# CHANGE ORDER

Project Name: **Stoughton Fire Station No. 1** CO No. **05r**  
400 Prospect Street

Architect's Project No. **19-0796**

## Change Order No. 05

**A4** WALL SECTION - @ COL. B/1  
1/2" = 1'-0"

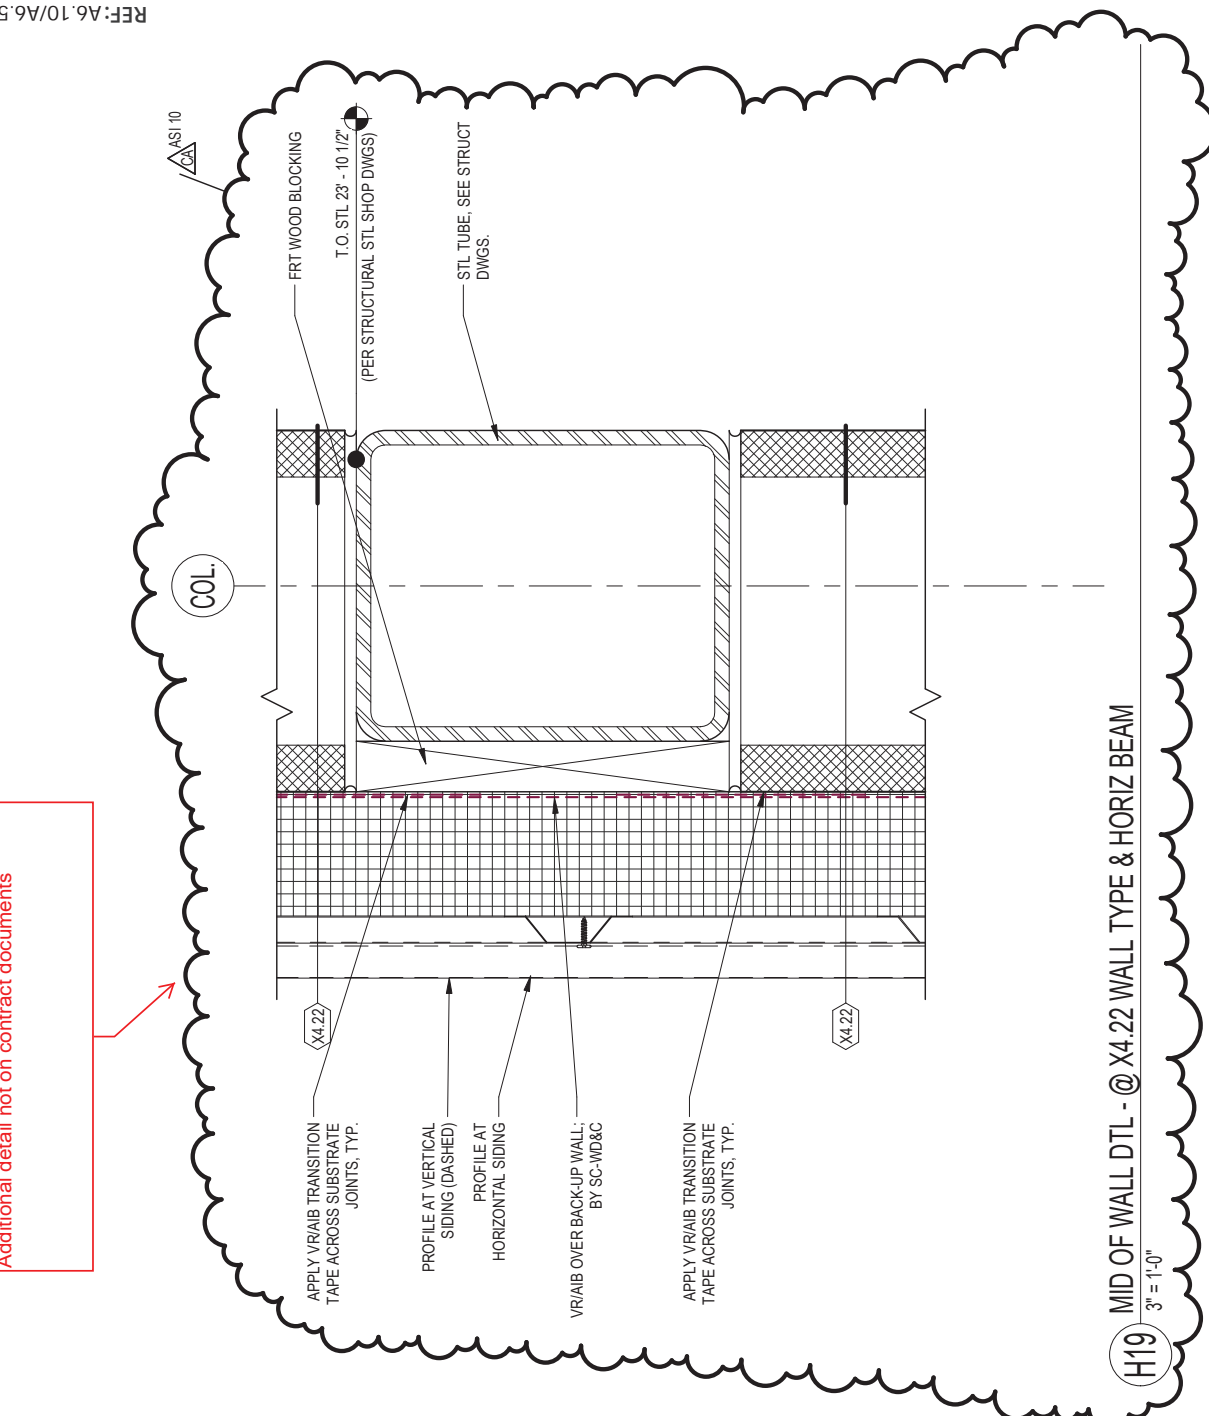
- At sheet A6.10, detail A4, revise wall section per JD40
- At sheet A6.51, add detail H19 – MID OF WALL DTL - @ X4.22 WALL TYPE & HORIZ BEAM, per JD40
- At sheet A8.10, window types legend, Type W7, revise Call out per JD39
- At sheet A8.60, add detail A17 – W7 HEAD DETAIL @ X4.22 WALL
